HOWARD COUNTY HEALTH DEPARTMENT
BUREAU OF ENVIRONMENTAL HEALTH
P.O. BOX 476 ELLICOTT CITY, MARYLAND 21043
TELEPHONE: 461-9933

PERCOLATION TESTING

A 47661
P _____

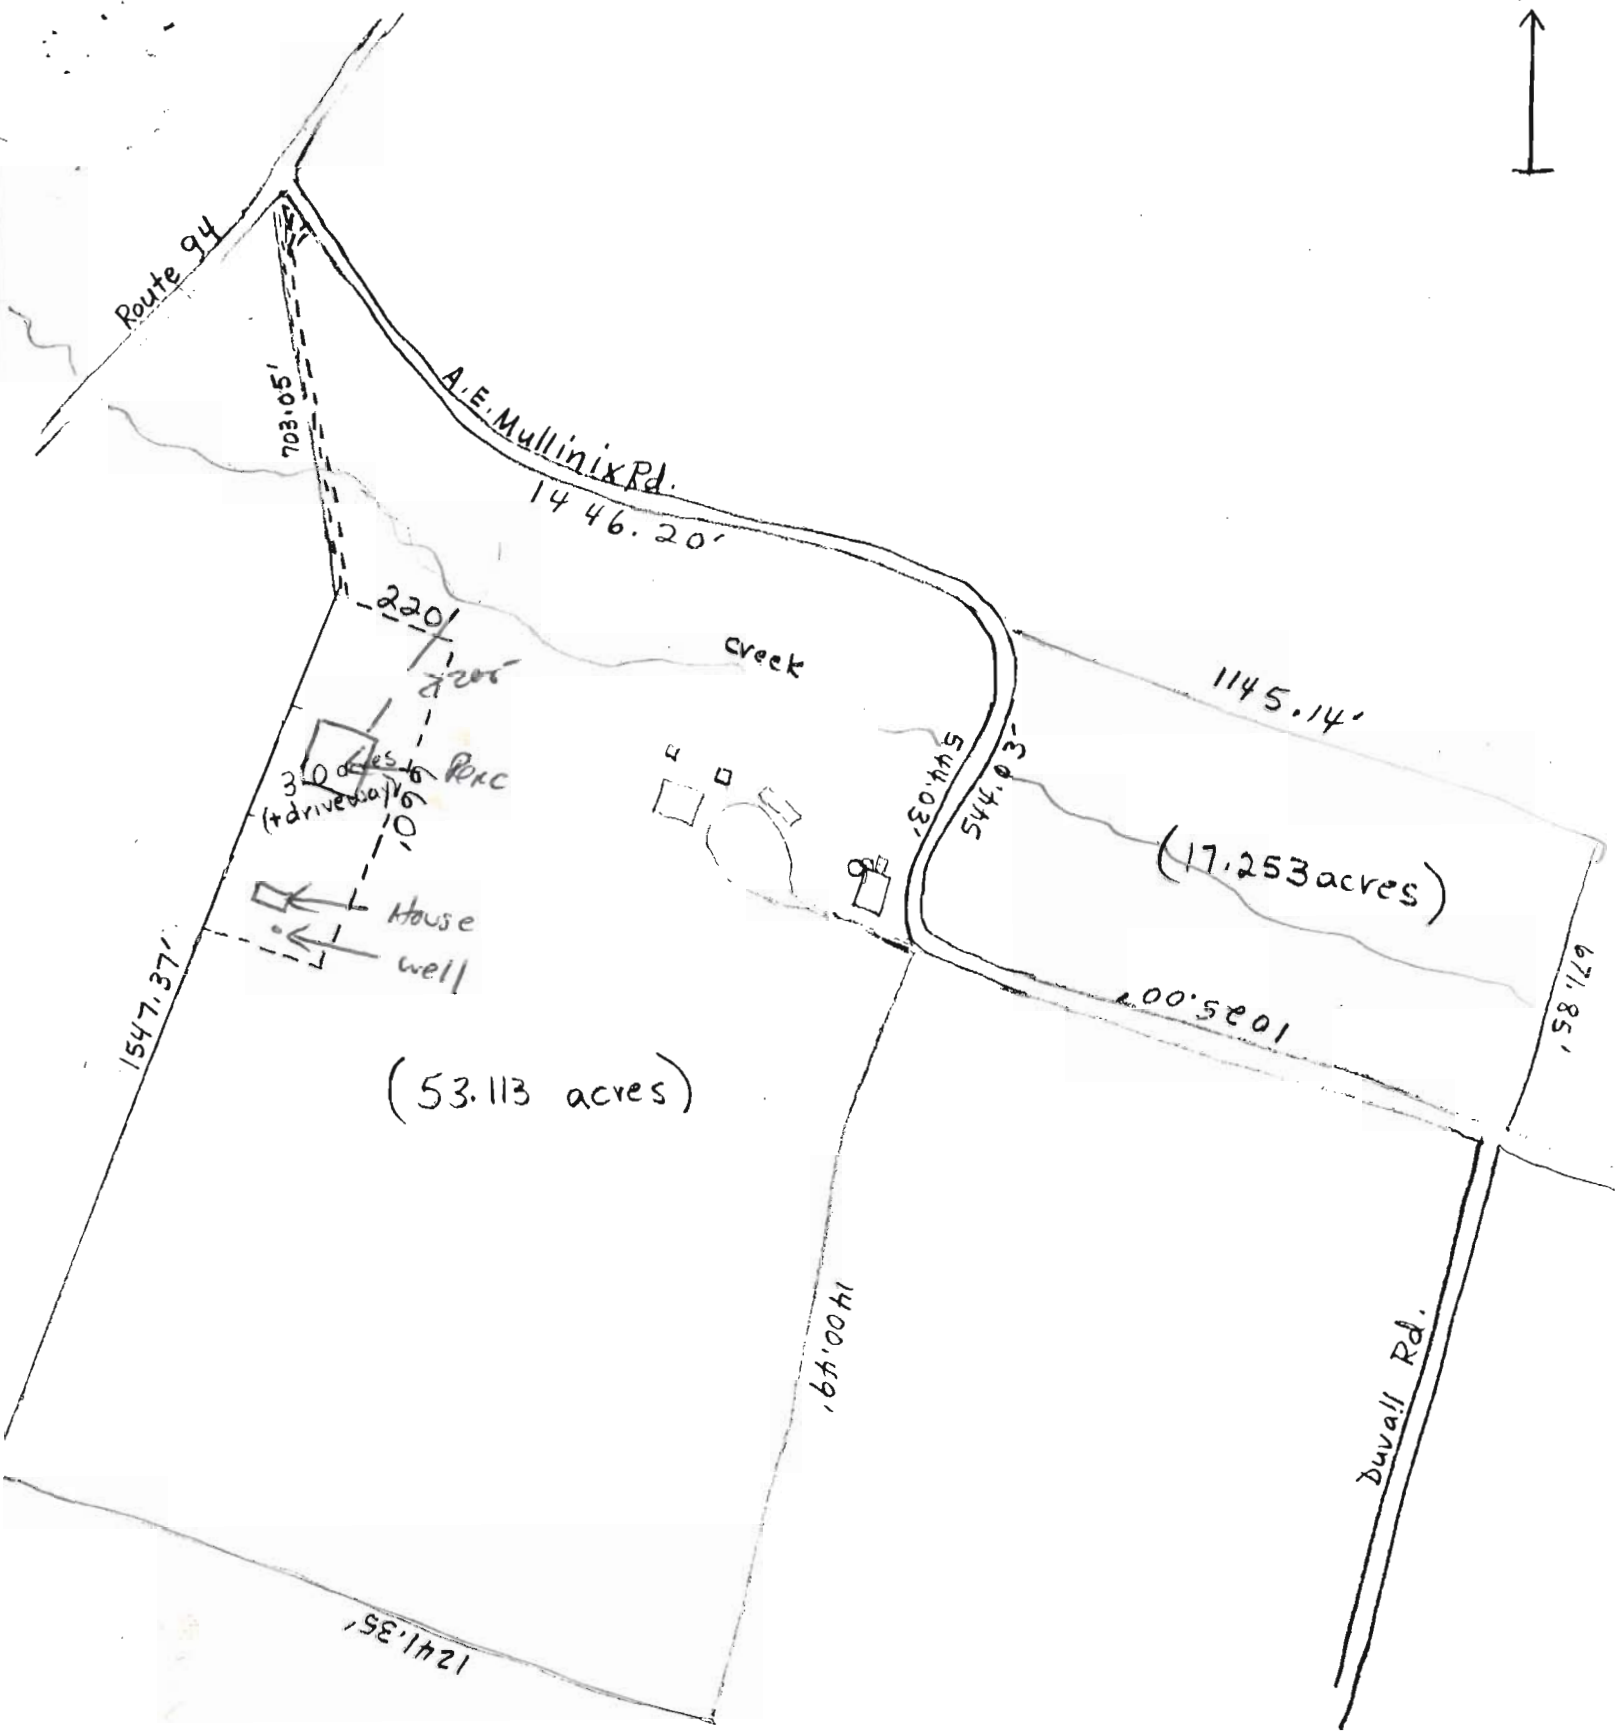
TO MAINTAIN REQUIRED
20' SEPARATION FROM STREAM.

OK TO TEST HIGHEST AVAILABLE AREA,

SATISFACTORY SOIL CONDITIONS MAY
STILL RESULT IN DENIAL IF SEPTIC
IS INSUFFICIENT DISTANCE FROM STREAM.

REASONS FOR REJECTION OR HOLDING REJECTED FOR DEEP CLAY TIGHT DISTANCE TO STREAM MR 12/18/91
SECOND ATTEMPT FOR PERC OK, HOLD FOR PLAT MR 1/10/92
